Attachment H

Clause 6.21C Design Excellence Assessment

Figure 4.3 - This diagram demonstrates that the building siting and footprint is characteristic of the location.

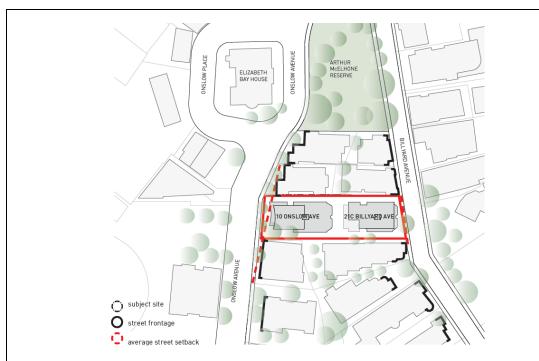
While the proposed development does not meet the separation distances in the design criteria in part 3F – Visual privacy in the ADG, the experts agree that Objective 3F-1 is satisfied. This requires that "adequate building separation distances are shared equitably between neighbouring sites, to achieve reasonable levels of external and internal visual privacy".

The proposed side setbacks of the building are similar or greater than those of the neighbouring buildings and are considered characteristic of the location. The architectural design incorporates brick screening and careful location of windows to manage overlooking from within the apartments. Overlooking from balconies and rooftop open space is managed by increasing separation and managing view angles with planters, nib walls and where required, screening.

The experts agree that the bulk, massing and modulation of the proposed buildings is suitable for the site and location.
